**NOTICE OF MEETING
PLANNING & ZONING COMMISSION
TUESDAY, MAY 5, 2026
T.W. "TURK" CANNADY – CEDAR HILL ROOM
CEDAR HILL GOVERNMENT CENTER
285 UPTOWN BLVD. – BLDG. 100
CEDAR HILL, TEXAS 75104
6:00 P.M.**

RE: Case No. FP-781-2026 (Final Plat – Milotte Margaret Estates, Lots 2R, 3R-1, and 3R-2, Block 1)

SEE SHEET 6

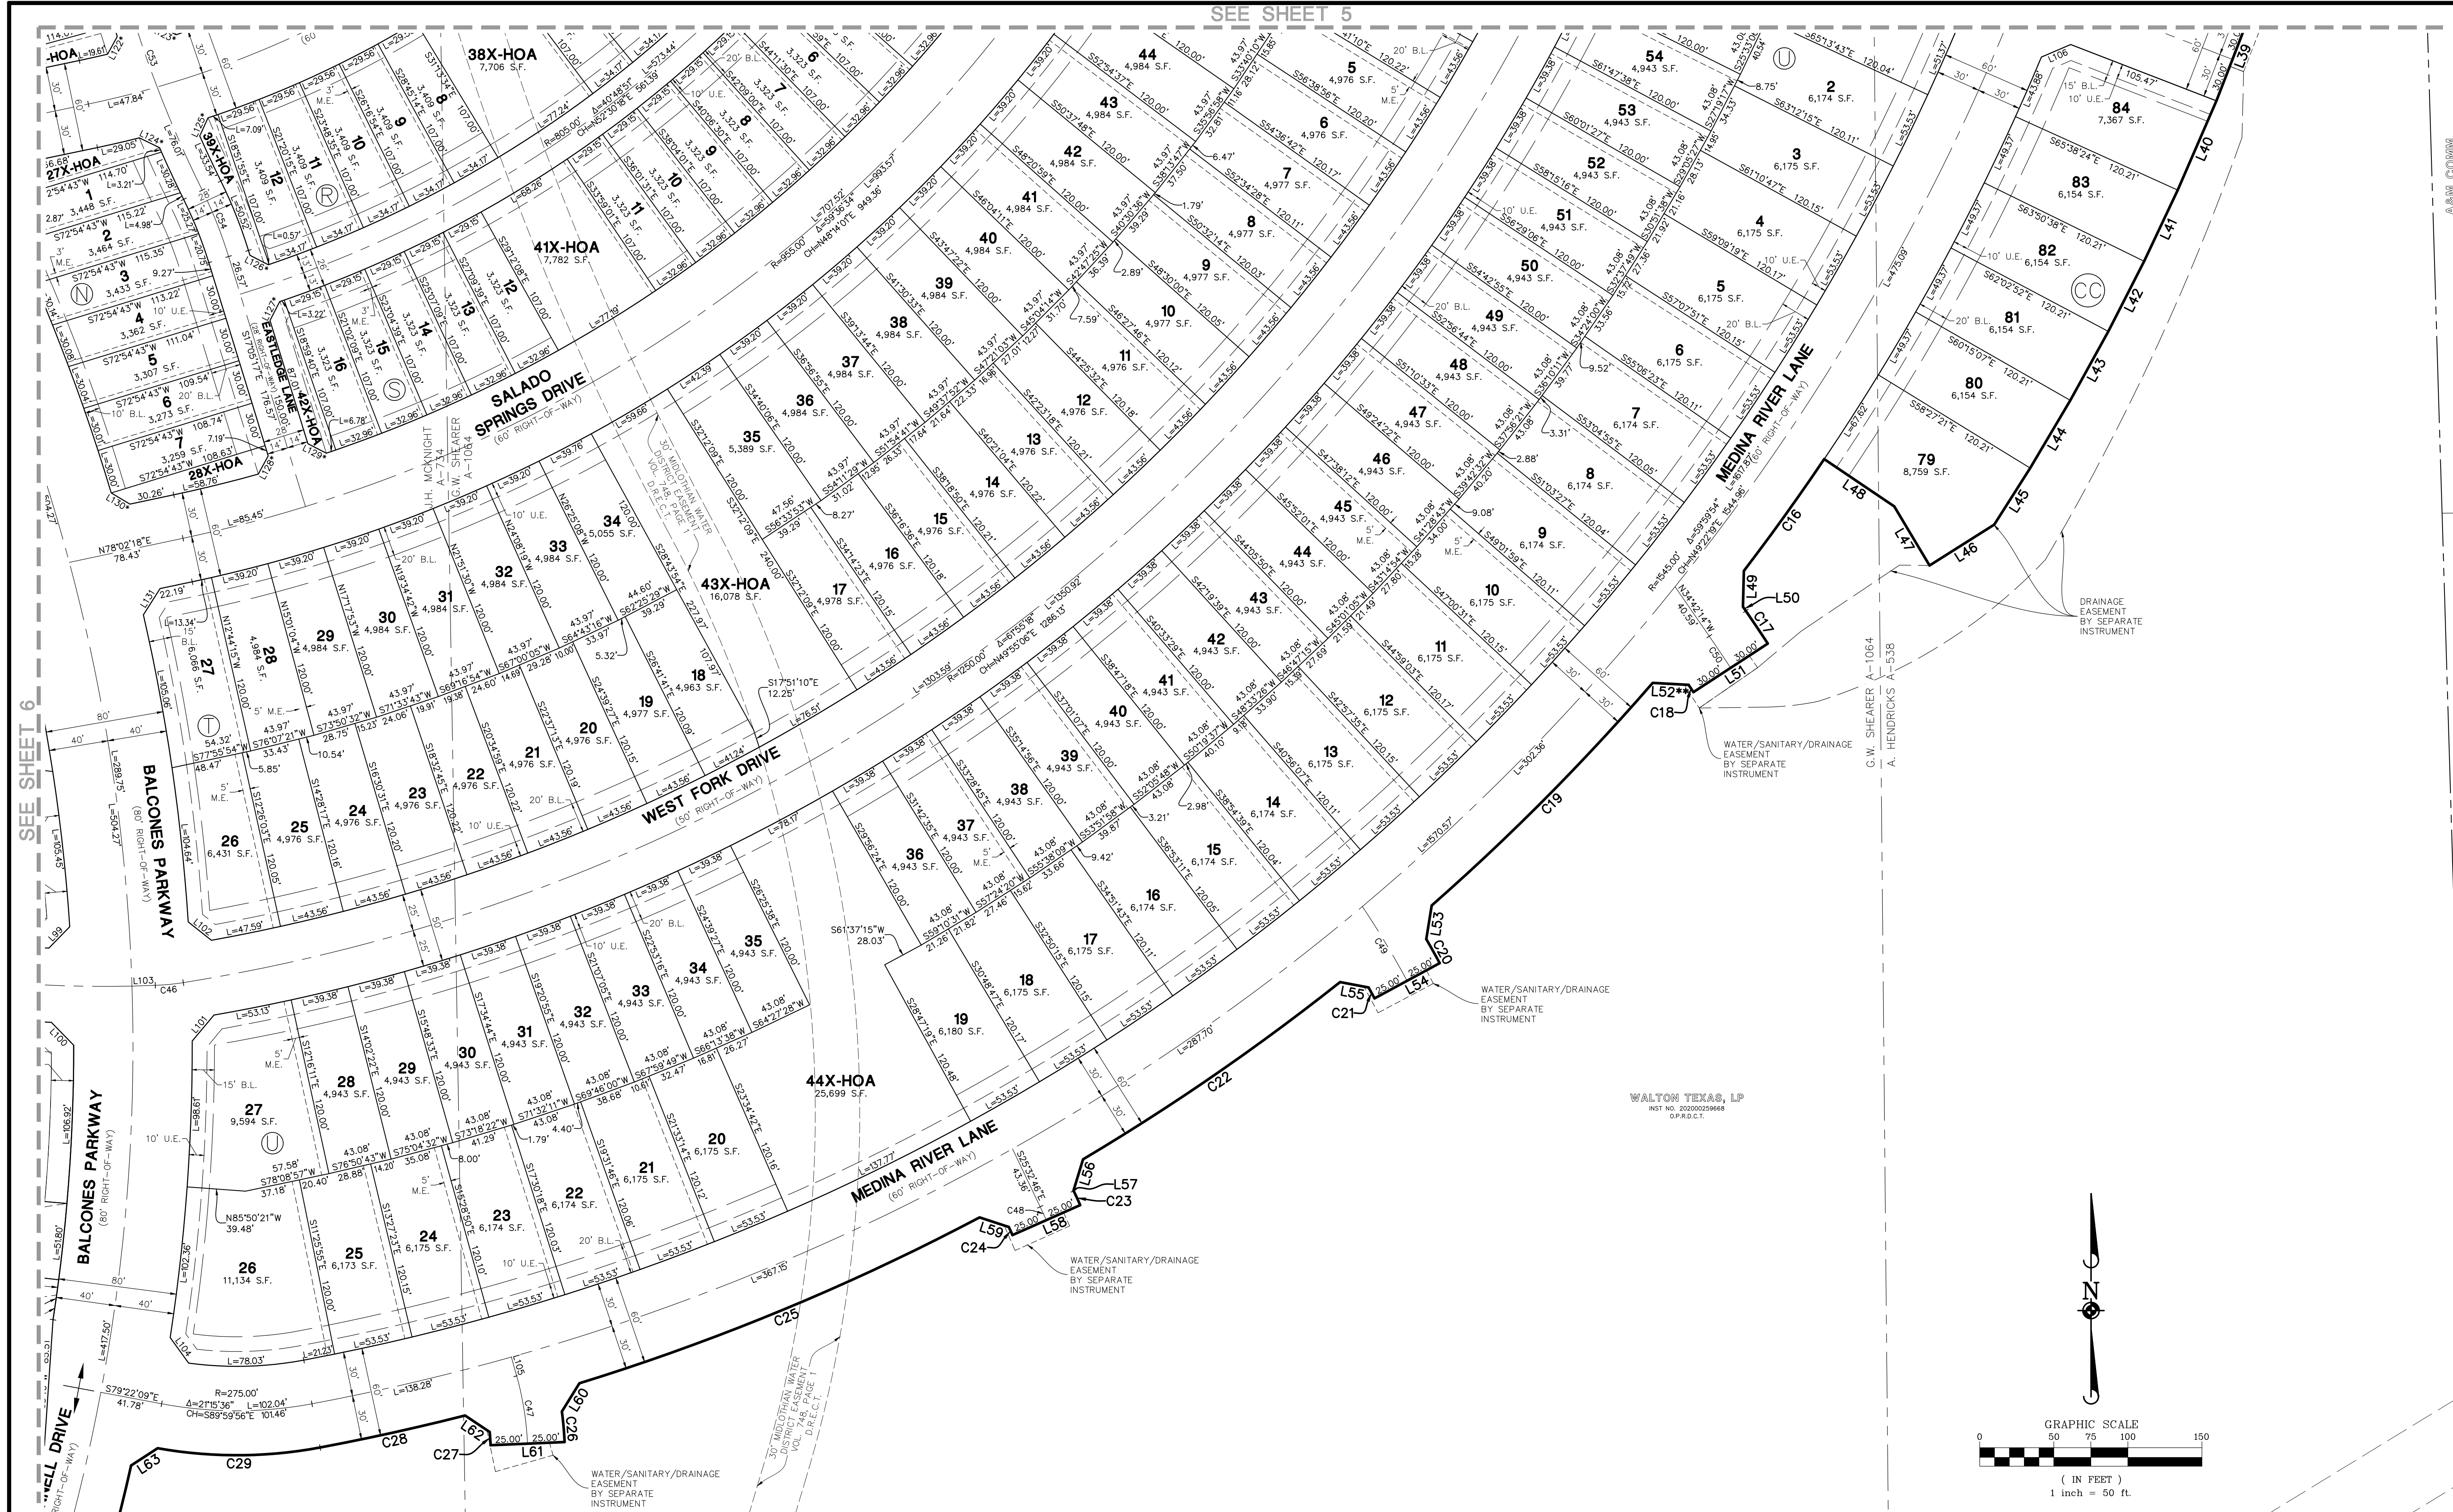
Planning Department	Code Citation
<p>1. Provide evidence of plat distribution to the applicable franchise utility companies.</p> <p>Simply send them an email to the applicable contacts, and copy the City and with the following: <i>"On behalf of the (applicant's name), we are submitting a final plat at (address) for a residential subdivision of 238 lots in Cedar Hill, Texas. If you have any questions, please contact me and/or the applicant."</i></p>	<p>Chapter 20, Section 20-11(c)(1) thru (9) of the Subdivision Regulations</p>
<p>2. Provide approval from the Post Office regarding the proposed residential subdivision layout PRIOR TO RECORDATION of the Final Plat.</p>	<p>Chapter 20, Section 20-11(c)(9) of the Subdivision Regulations</p>
<p>3. Provide a certified copy of the owner association agreement and association by-laws where required for maintenance prior to the recordation of the plat.</p>	<p>Chapter 20, Section 20-11(b)(21)(b) of the Subdivision Regulations</p>

<p>4. Add case no. FP-782-2026 underneath the Title Block.</p>	
<p>5. This property is within both Dallas County and Ellis County. Staff contacted both Counties requesting requirements for the recording of this Plat.</p> <ul style="list-style-type: none"> • Ellis County response – plat must meet both Texas Property Code for recording and TLGC. Plat sheet size must be 18"x24". • Dallas County response – plat must clearly show/delineate both Counties. Typical Plat sheet size is 24"x36", but they will accept 18"x24". <p>Contact each county directly to confirm and revise sheet layout as needed.</p>	<p>See the attached County correspondences</p>
<p>6. Provide the following note on the plat. "Selling a portion of this addition by metes and bounds is a violation of the Subdivision Regulations and State law and is subject to the withholding of utilities and building permits."</p>	<p>Chapter 20, Section 20-2 of the Subdivision Regulations and TLGC, Section</p>

212.004
7. Remove all building lines and/or yard setback lines and call outs from the proposed plat. Add the following note on the plat. "Building setbacks shall comply with the Zoning Ordinance at the time of the Building Permit."	Chapter 20, Section 20-11(b)(9) of the Subdivision Ordinance

8. Provide the bearing and distance information for all proposed easements.	Chapter 20, Section 20-11(5) of the Subdivision Ordinance
9. Label all existing and proposed easements.	Chapter 20, Section 20-11(b)(5)c of the Subdivision Ordinance

10.The table listing the residential lots and the HOA/Open Space lots has missing lot numbers. Please revise.	Chapter 20, Section 20-10.b(8) of the Subdivision Ordinance

11.Provide the recording information for all proposed off-site easements and/ or easements not by this plat, on this plat prior to the recordation of the plat.

12. Revise the Title Block to separate how many acres are in Dallas County and Ellis County. Add "Addition" to the Title Block and under "Dedication".	Chapter 20, Section 20-11(b)(11) of the Subdivision Regulations; Chapter 20, Section 20-11(f) of the Subdivision Ordinance

13.Per PD, A minimum of 10% of the total 30' / 40' / 50'/ 60 -ft lots with the property may be allowed no more than 5% reduction in area due to site constraints. Verify and confirm.	PD No. 2024-813 Section 10

14. Provide an exhibit that overlays the following information on a plat layout to confirm the maintenance easement locations on this plat: a. all the retaining walls required per engineering plans b. all the fences/screening walls required that will be owned and maintained by the HOA per Section 10.O of PD-2024-813. c. all the maintenance easements associated with walls and fences listed above.	Chapter 20, Section 20-11(b)(19)

15. Remove the telephone and email address from plat.	
16. Add "By this plat" to all proposed plats and add "Dedicated by this plat" to all city properties.	
17. Label all HOA lots on all sheets	
18. Confirm that the meets and bounds does not have to be separated per county property.	
19. Add the Title within the Meritage Homes of Texas Organization for Frank Su under the Dedication Certificate.

Parks Department	Code Citation
1. Park Land Dedication per PD Ordinance has been satisfied. The park development fee of \$700 per dwelling unit will be required. The developer is constructing a 10-foot concrete city trail that is approximately 3,300 linear feet with Phase 1 infrastructure improvements. The developer may utilize this fee requirement for the construction of this trail. Please provide a cost estimate (OPC) for the construction of this trail.	Chapter 20, Section 20-42(c) & Section 20-43(a) of the Subdivision Regulations
2. Provide 10-ft Trail Easements for the trail sections that cross HOA lots.

Public Works Department	Code Citation
1. Provide Northern and Easterlings for at least two corner pins for reference in city GIS system.	Chapter 20, Section 20-11(b)(3) of the Subdivision Regulations
2. Please remove the escarpment limits and contact line from the Plat. However, a note shall be added that the escarpment exists and that there is a plan associated. This shall comply with the City Ordinance and the escarpment plan.	Chapter 20, Section 20-75(c) of the Subdivision Regulations
3. Please indicate that City lots are being dedicated by this Plat.	
4. Please add a note stating any changes in the approved grading plans shall be submitted to the city.
